# PICCADILLY WAREHOUSE

Mindel House & Bloom Street

Design and Access Statement Addendum

Section 73/19

## Mindel House. North West Elevation

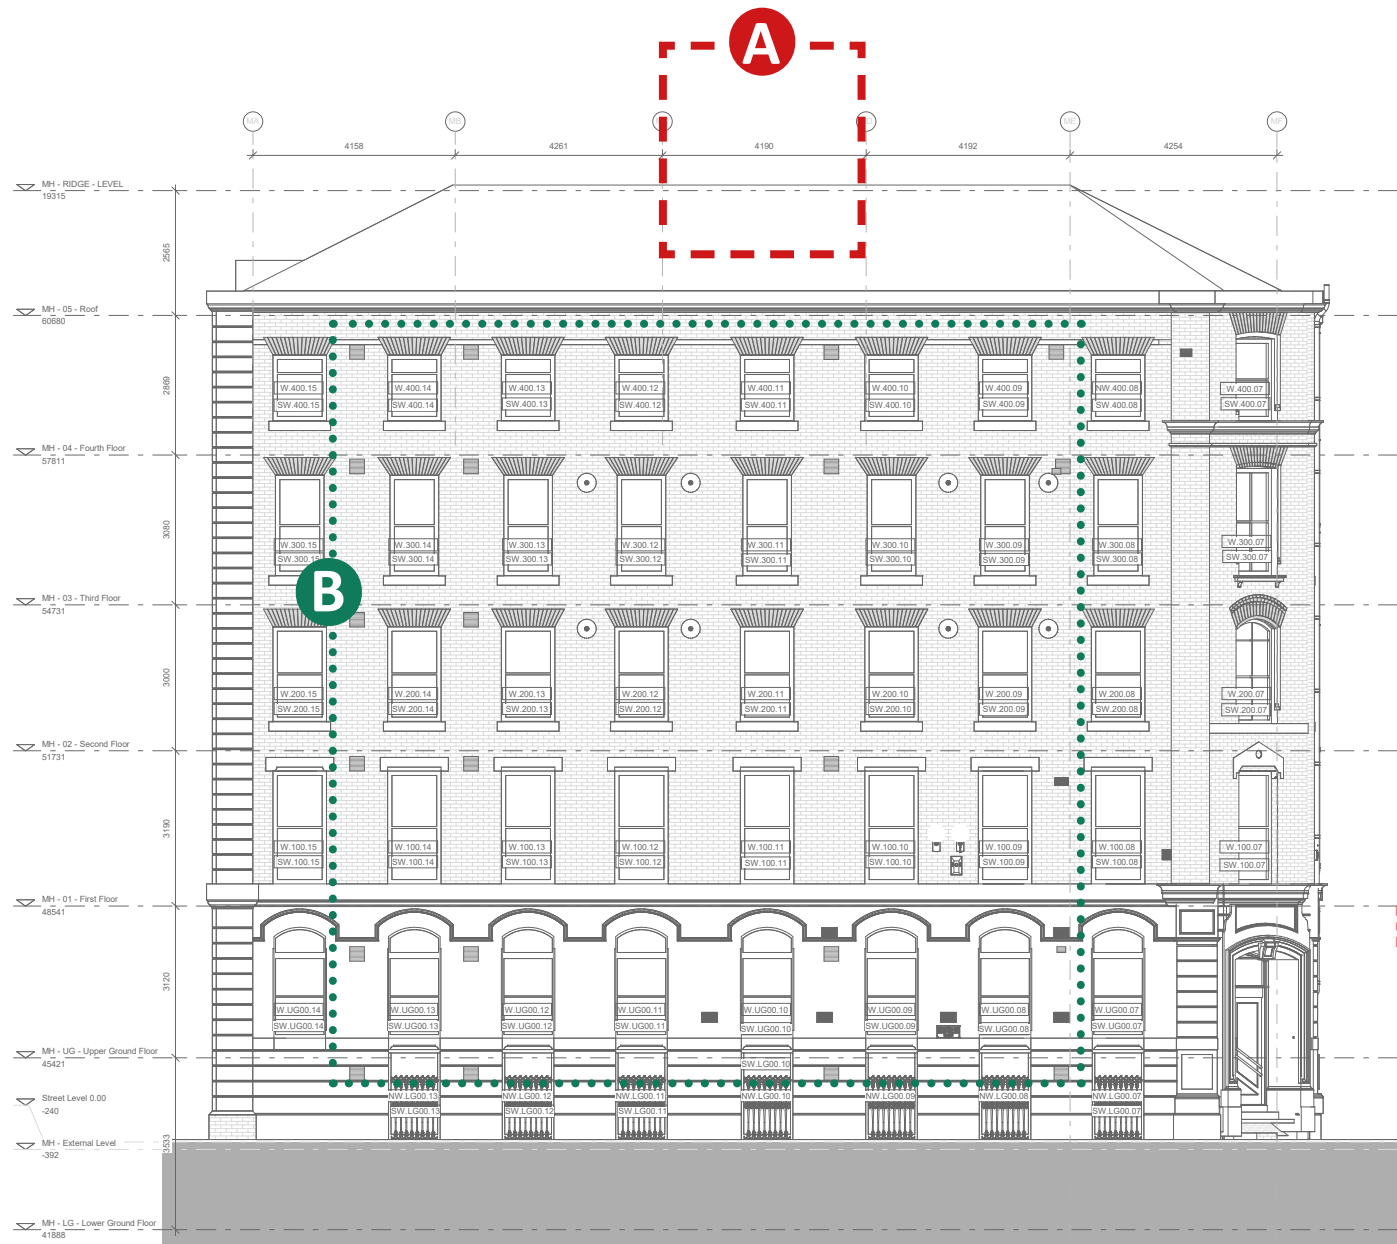
**A** Masonry Hoist: Proposed to be cut below central flat roof level to make space for required plants.

**B** Ventilation grills:  
According to the ventilation strategy, MVHR units require supply and extract duct to penetrate the existing facade. New holes are approx. 200x200mm.  
It is therefore proposed to introduce 250x250 cast iron ventilation grills, with the design aligned with grills existing on site.

**B** A.O.V Hatch: Approved location above lobby not functional. Proposed to be relocated above stairs.

Mindel House. North East Elevation

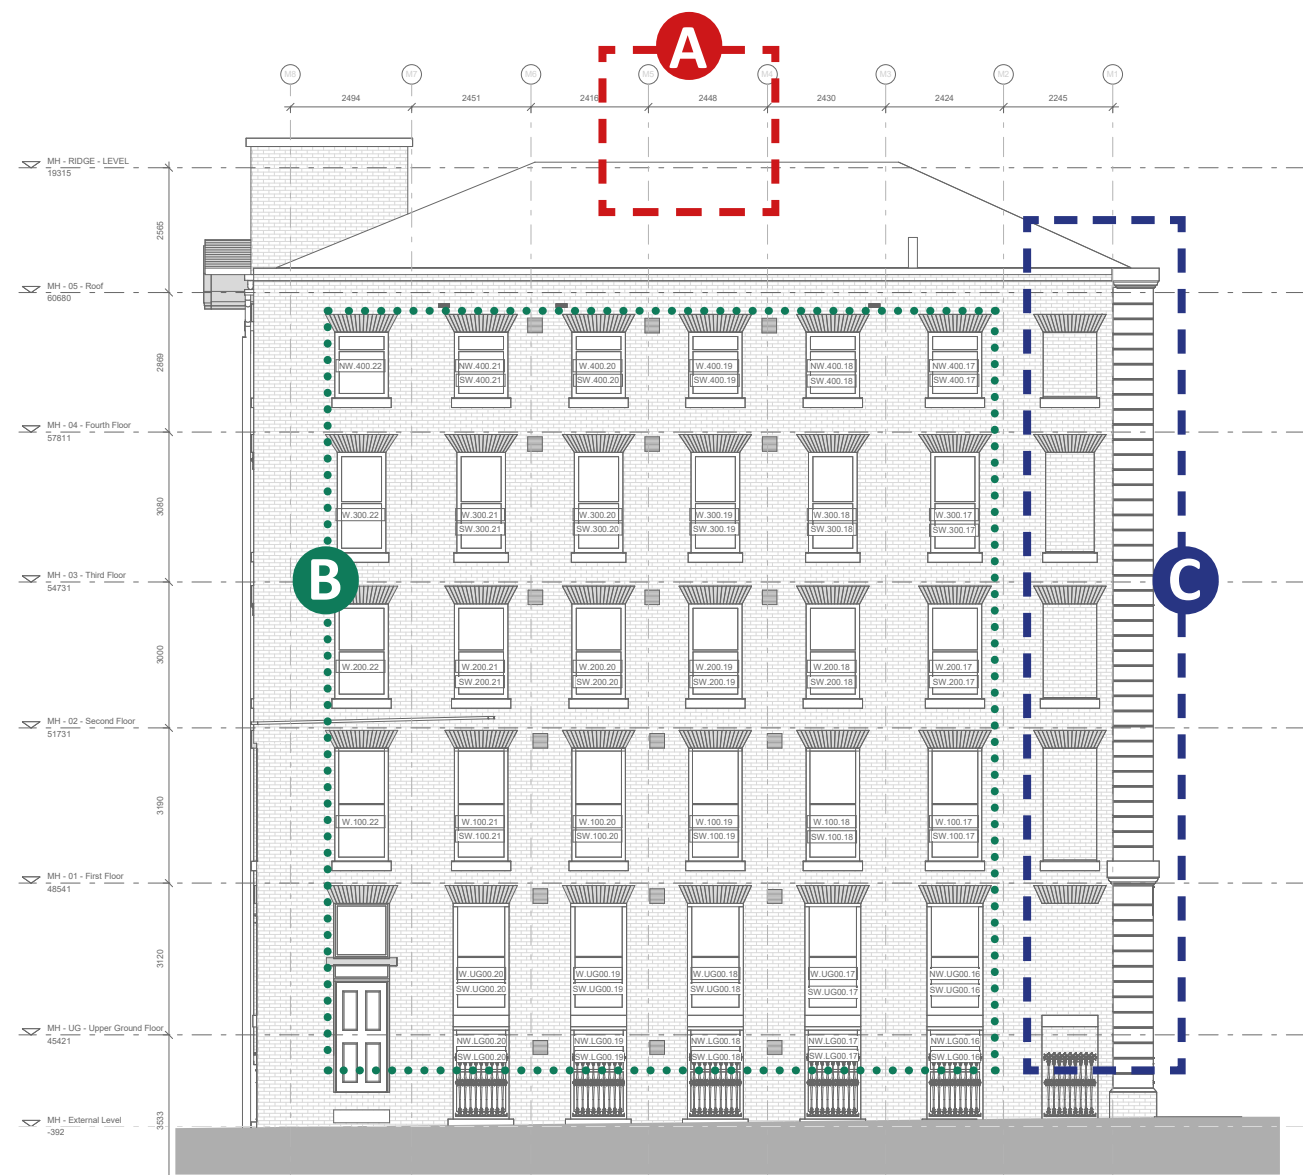
**A** Masonry Hoist: Proposed to be cut below central flat roof level to make space for required plants.

**B** Ventilation grills:  
According to the ventilation strategy, MVHR units require supply and extract duct to penetrate the existing facade. New holes are approx. 200x200mm.  
It is therefore proposed to introduce 250x250 cast iron ventilation grills, with the design aligned with grills existing on site.

Mindel House. South East Elevation

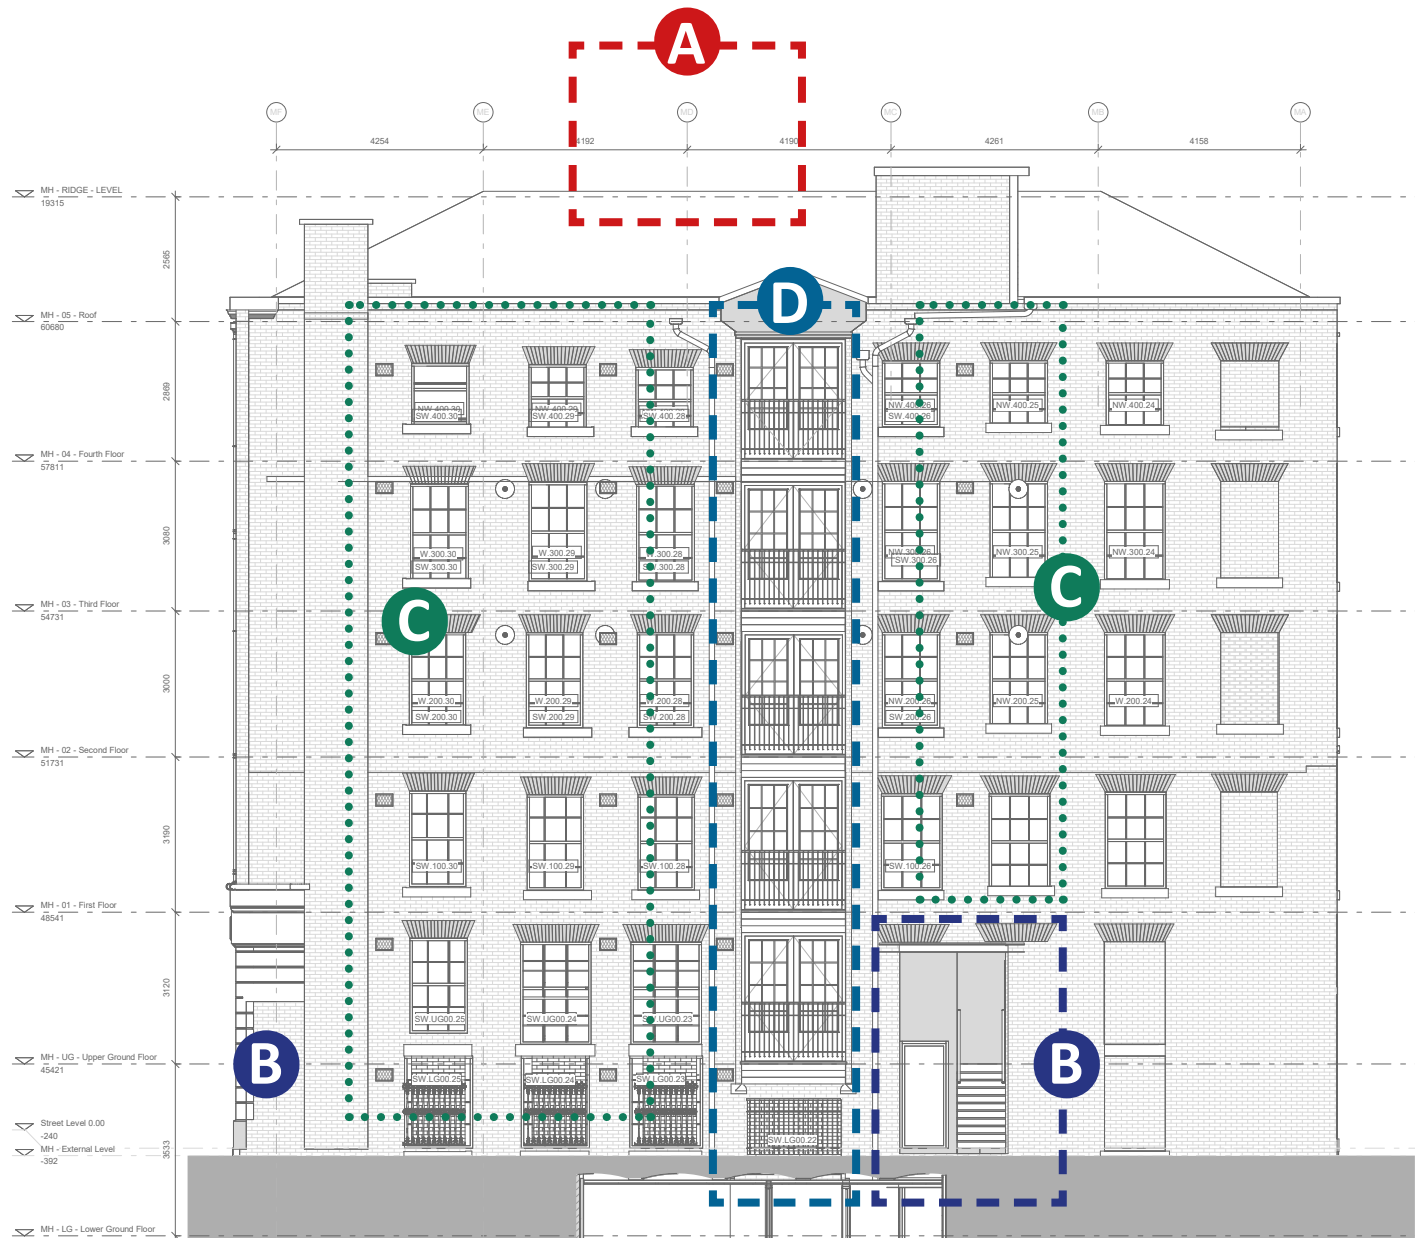
**A** Masonry Hoist: Proposed to be cut below central flat roof level to make space for required plants.

**B** Ventilation grills: According to the ventilation strategy, MVHR units require supply and extract duct to penetrate the existing facade. New holes are approx. 200x200mm. It is therefore proposed to introduce 250x250 cast iron ventilation grills, with the design aligned with grills existing on site.

**C** Blocked windows: Proposed to be opened in approved scheme, however their brickwork infill appears to be part of original design and therefore is proposed to be kept in place.

Mindel House. South West Elevation

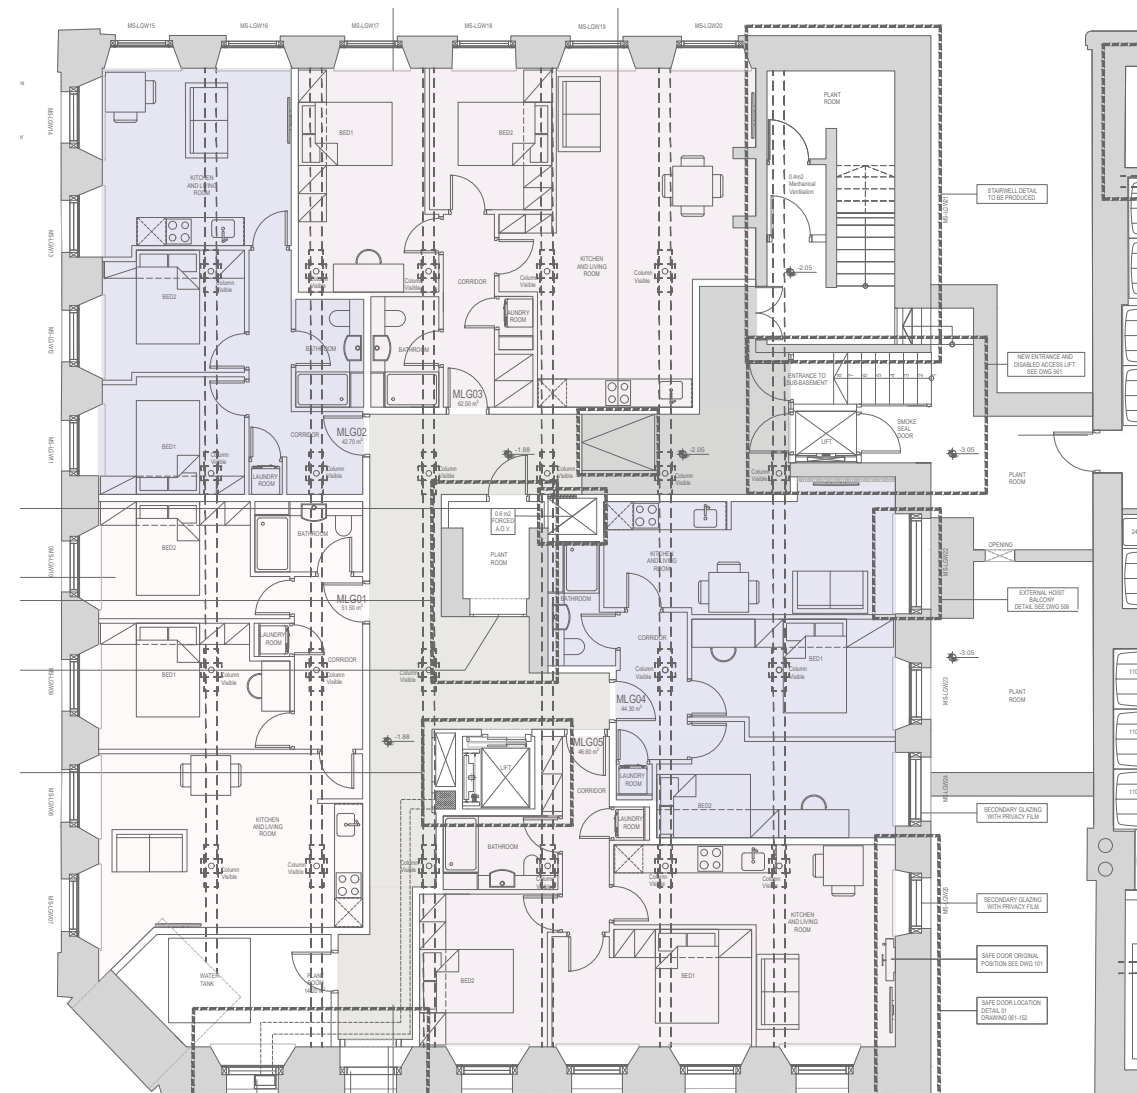
**A** Masonry Hoist: Proposed to be cut below central flat roof level to make space for required plants.

**B** Alleyway entrance: Design revised to fit area (now surveyed) with finishes for new elements now coordinated with Bloom Street Alleyway entrance.

**C** Ventilation grills: According to the ventilation strategy, MVHR units require supply and extract duct to penetrate the existing facade. New holes are approx. 200x200mm. It is therefore proposed to introduce 250x250 cast iron ventilation grills, with the design aligned with grills existing on site.

**D** Hoist doors: Now following the design of original timber and glazed double doors found in place at level 3 hidden behind solid timber panels. New elements will be in timber with slim double thin glazing. External balustrades required. Minimalist design.

Mindel House. Lower Ground Floor

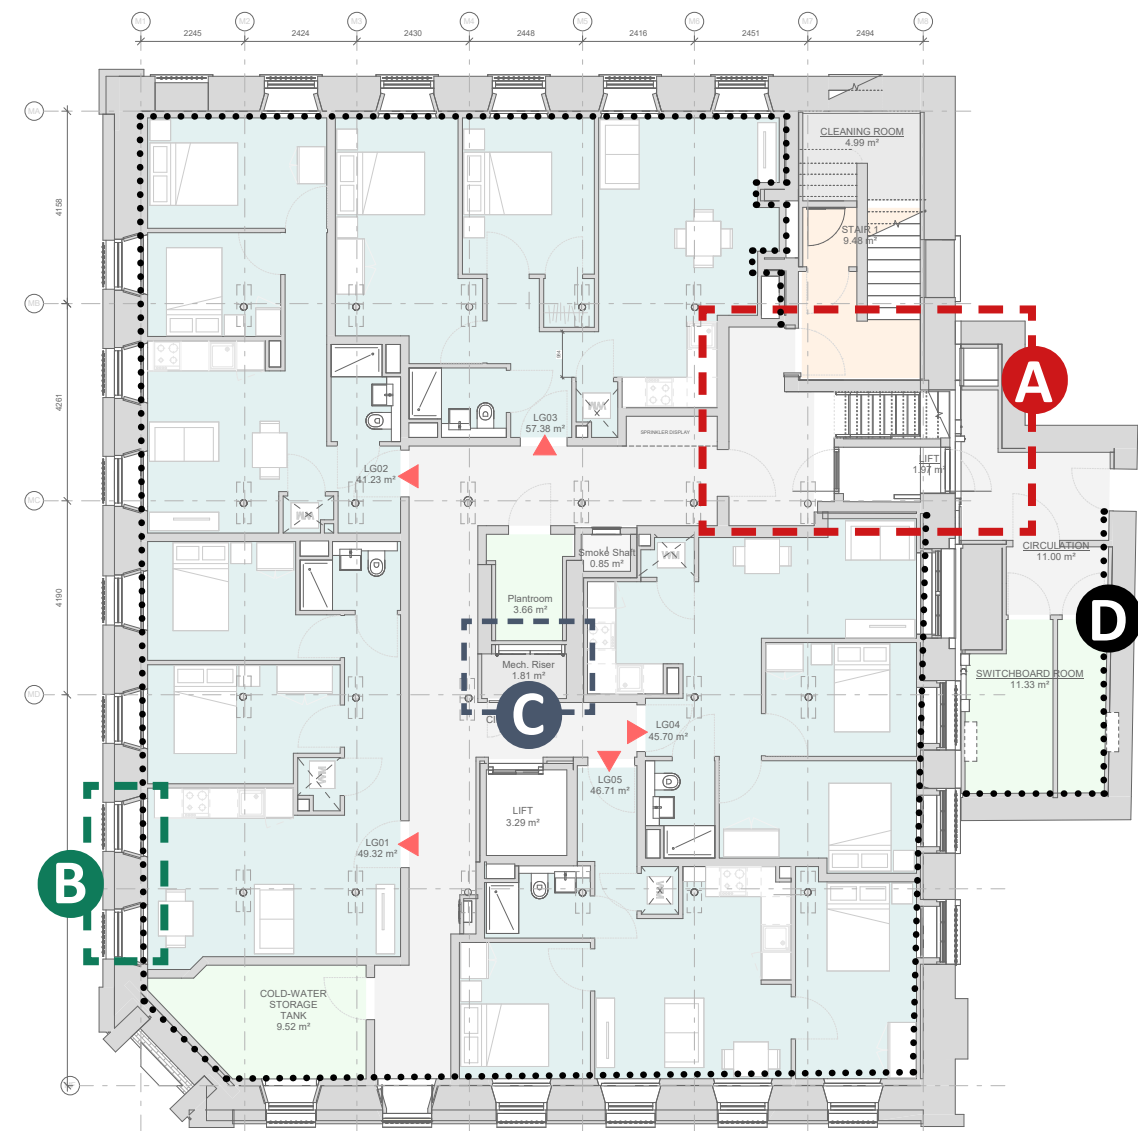
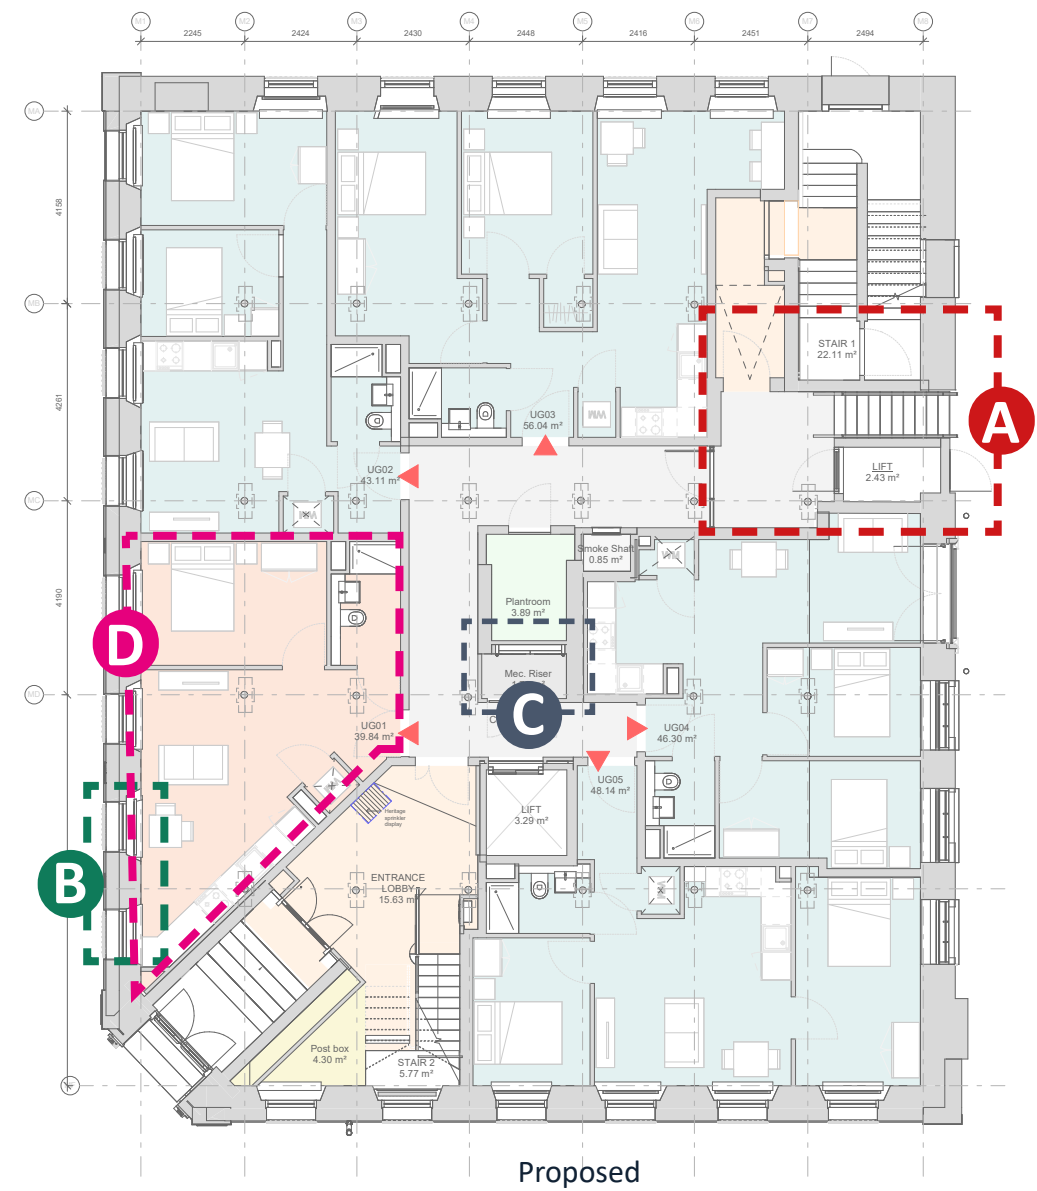
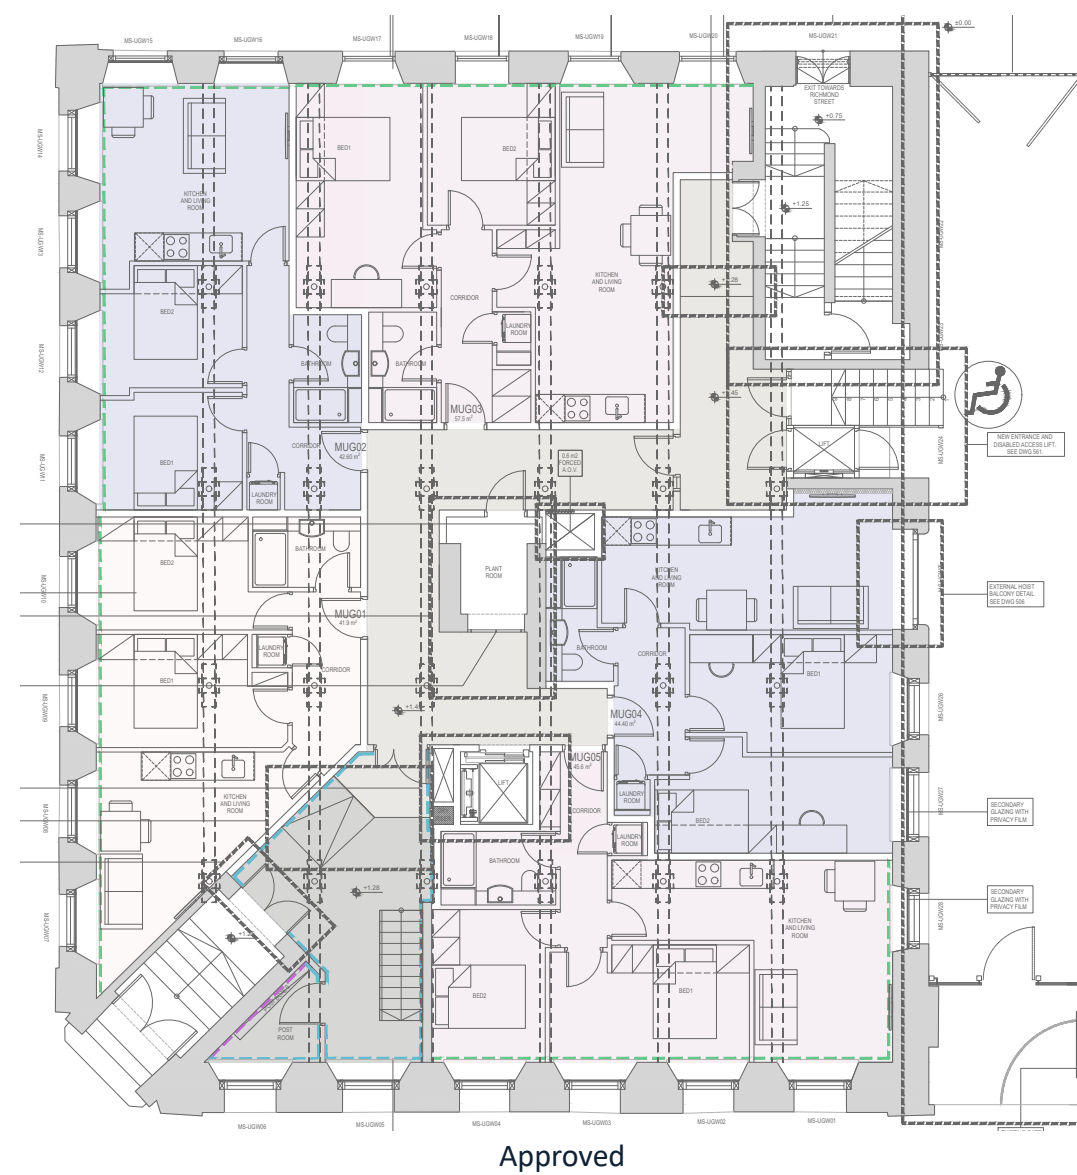
- Apartment layout: Improved efficiency and open plan arrangement where possible.

- A** Basement entrance: Design revised to fit area (now surveyed)
- B** Historic sprinkler valves+pipes: Now proposed to be refurbished and relocated within communal corridor
- C** Plantroom: Mechanical plant added for functional reasons.
- D** Tanking system
